**PROPOSED RESIDENTIAL DEVELOPMENT,
FORMER LILLEY AND STONE HIGH SCHOOL LONDON ROAD NEWARK, (3876)
APPLICATION REFERENCE PREAPM 00260 23
RESPONSE TO NOTTINGHAMSHIRE COUNTY COUNCIL COMMENTS - DECEMBER
2023**

This note has been prepared in response to comments received from Nottinghamshire County Council (NCC) dated 24th November 2023.

The comments concern the Transport Assessment (TA) submitted in October 2023 in support of PREAPM 00260 23 for Full Planning permission for Demolition of existing buildings, conversion of 3 no. retained heritage buildings to provide 32 apartments and erection of 43 new dwellings including access, parking and landscaping; and Outline planning permission for the erection of up to 64 new dwellings (all matters reserved except access) at the former Lilley and Stone High School, London Road, Newark.

Figure 11 - Total Development Traffic Flows (PCUs)

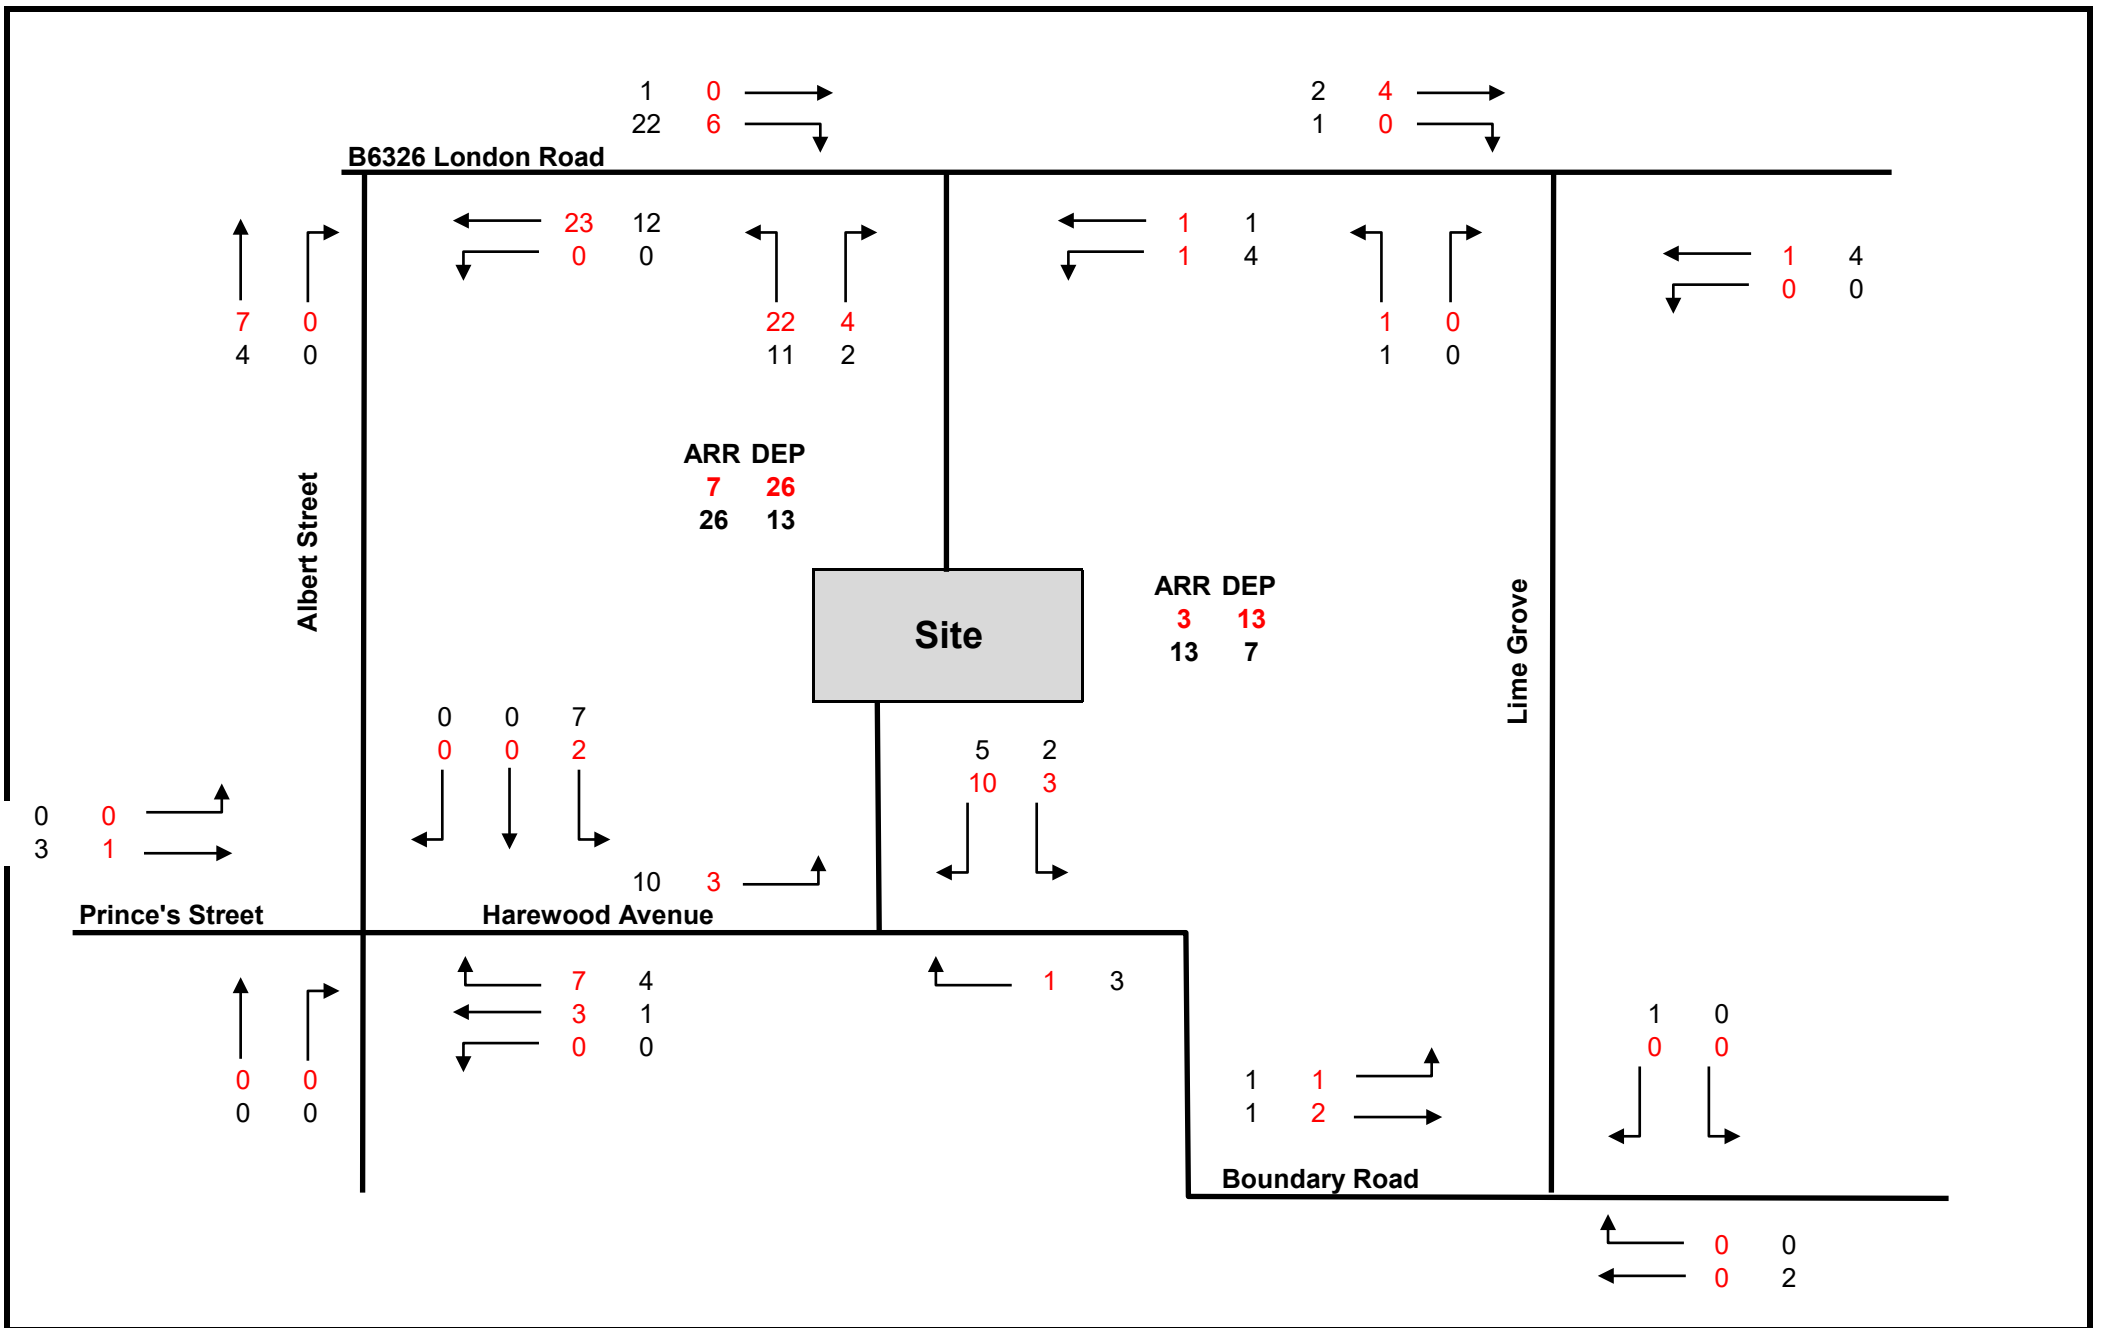
Notwithstanding the matters that would need to be addressed before coming to a conclusion, Figure 11 shows 61 additional vehicles at the junction of London Road with Albert Street. The minimum accepted threshold at which assessments should be carried out is where a development increases traffic by 30 or more. This is clearly exceeded at this junction which will require assessment and the gravity model should be extended to the point whereby vehicles are dispersed and no longer trigger an additional 30 vehicles.

As previously discussed, the study area will be amended following agreement of the development trip rates, which influence the extent of the road network impacted by 30+two-way development traffic flows.
